Atomic Industrial Forum, Inc.  
7101 Wisconsin Avenue,  
Washington, D.C. 20014  
Telephone: (301) 654-9260  
TWX 7108249602 ATOMIC FOR DC

The Atomic Industrial Forum's Committee on Power Plant Design, Construction and Operation has reviewed Draft NUREG-0814, "Methodology for Evaluation of Emergency Response Facilities", and offers the attached detailed comments consisting of marked up pages in the margins of the draft document.

# Methodology for Evaluation of Emergency Response Facilities

*AIF COMMITTEE ON  
POWER PLANT DESIGN,  
CONSTRUCTION AND OPERATION  
COMMENTS IN MARGIN  
IN RED INK*

FIGURE 2.1

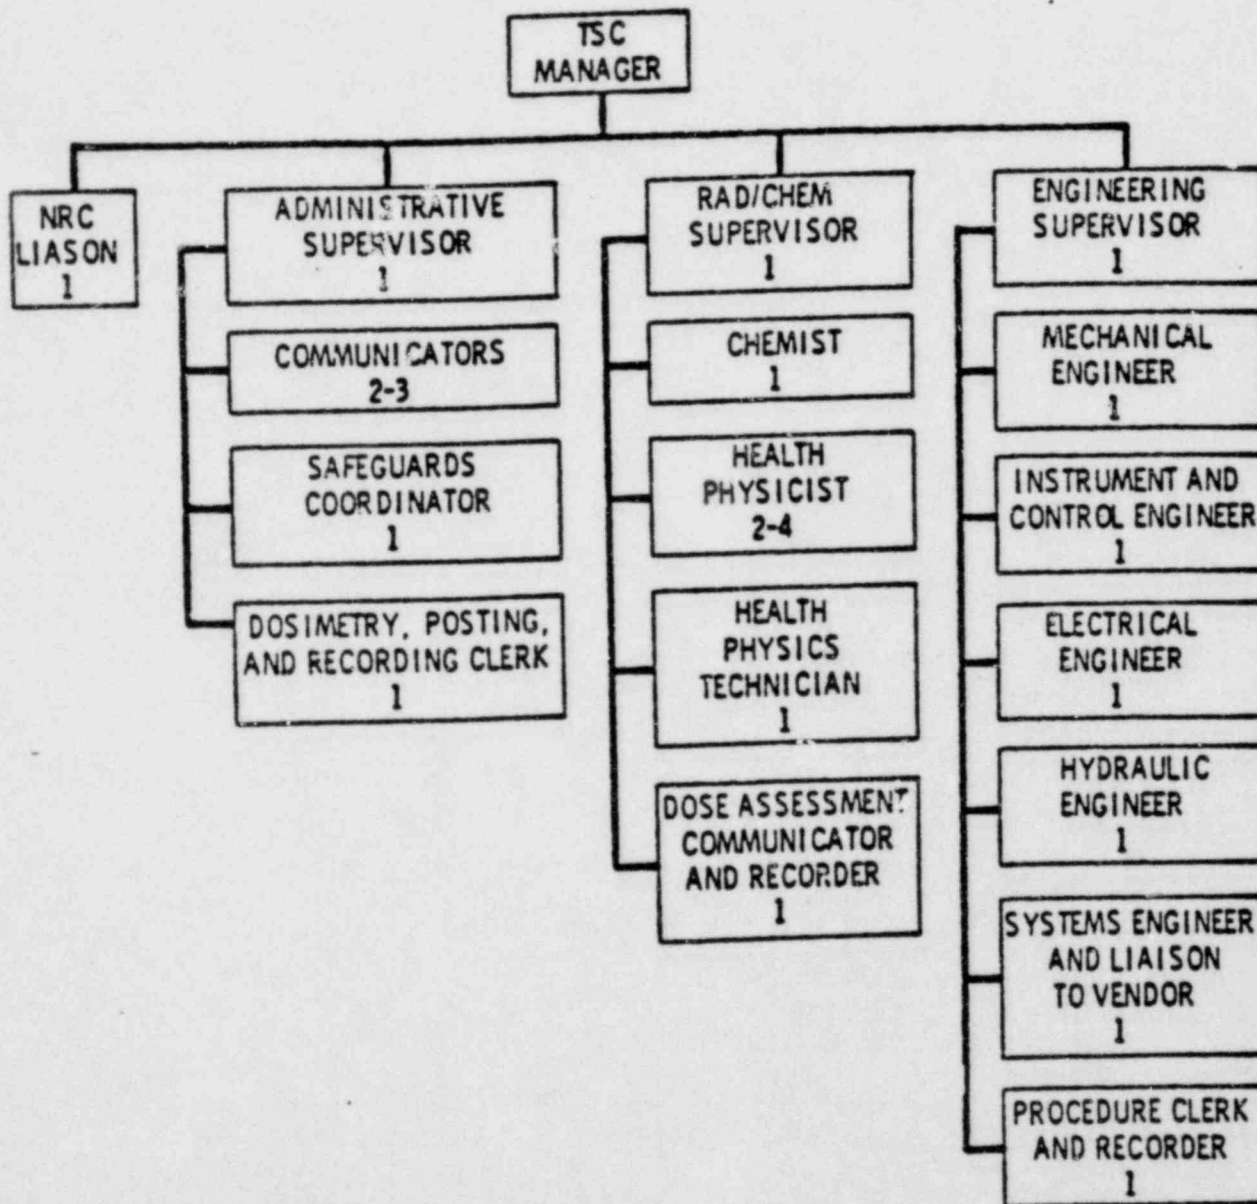
EXAMPLE ONLY

FIGURE 3.1

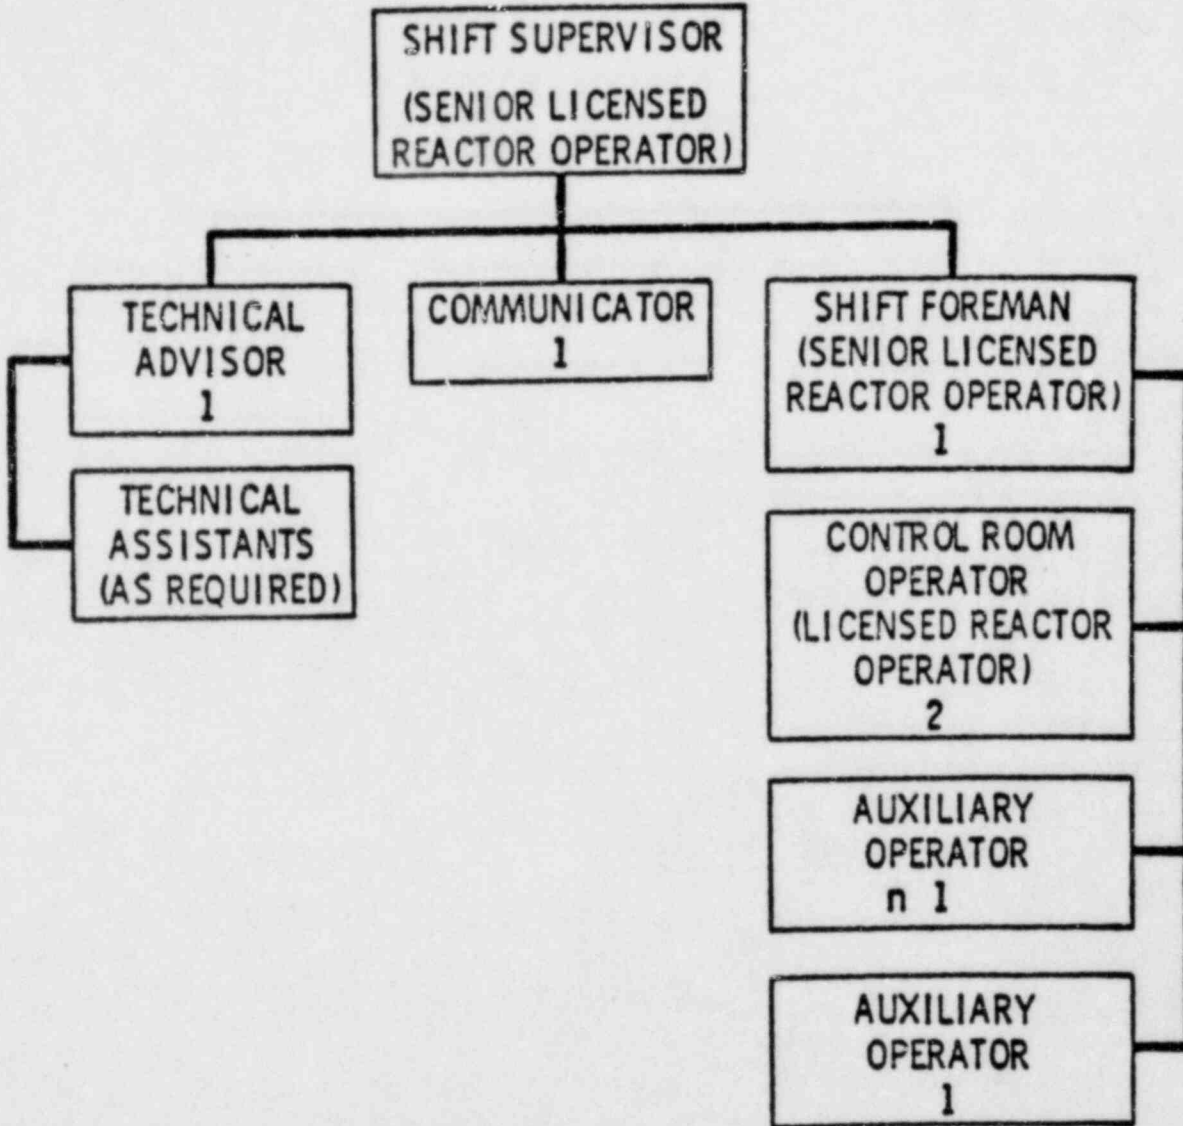
INAPPROPRIATE FOR  
THIS DOCUMENT

FIGURE 3.2

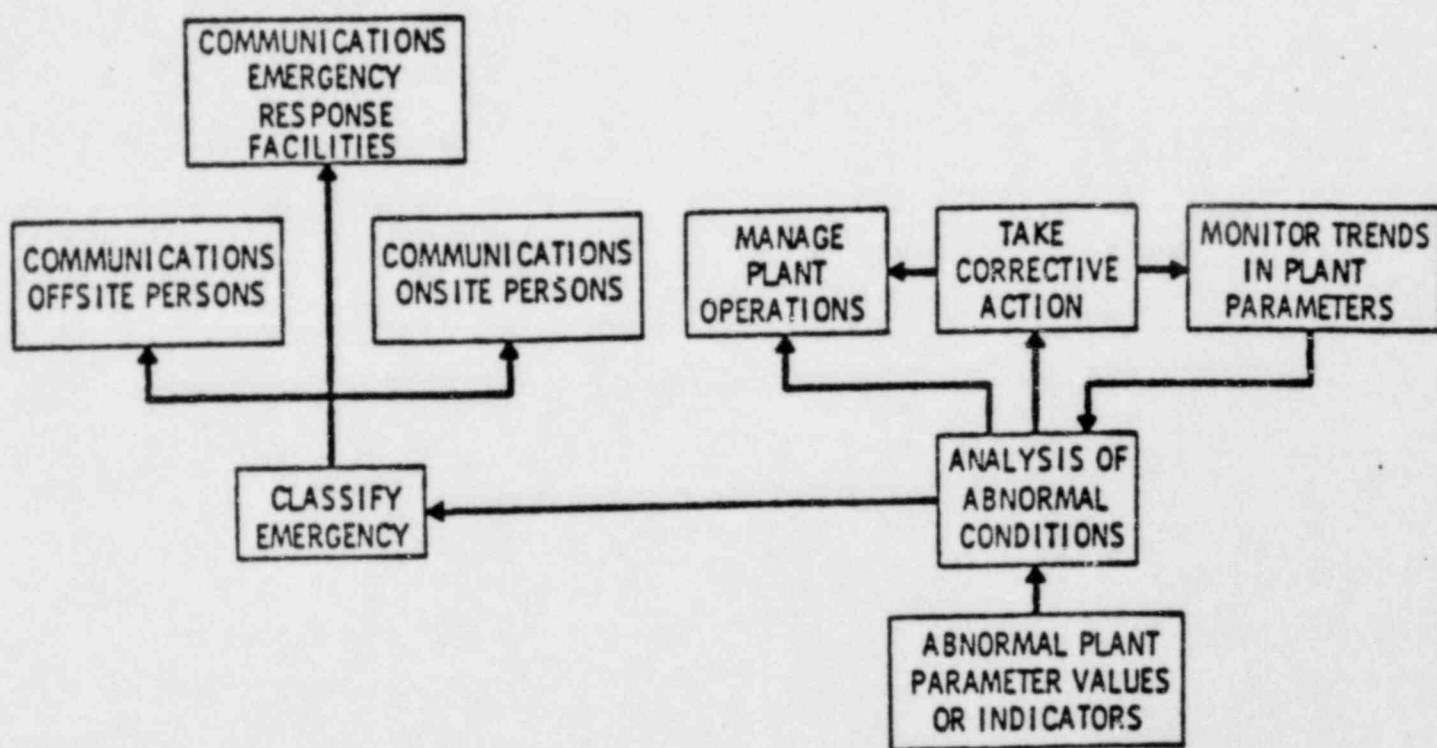
FUNCTIONAL UNTIL TSC OPERATIONAL

FIGURE 5.2

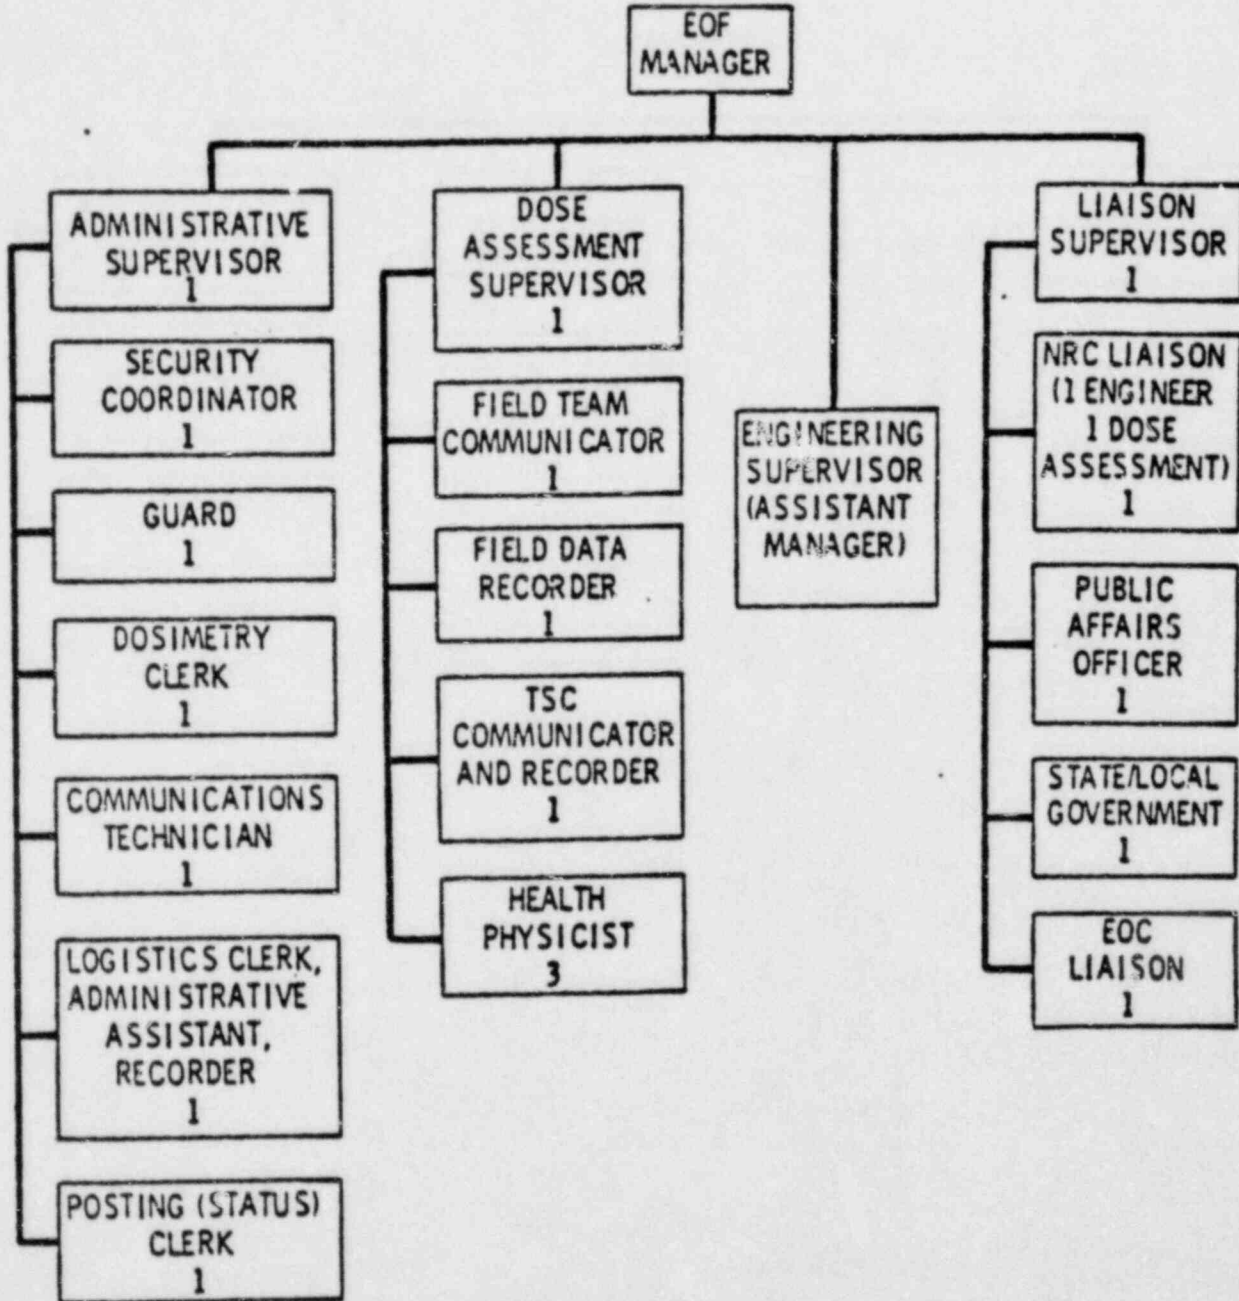
EXAMPLE ONLY
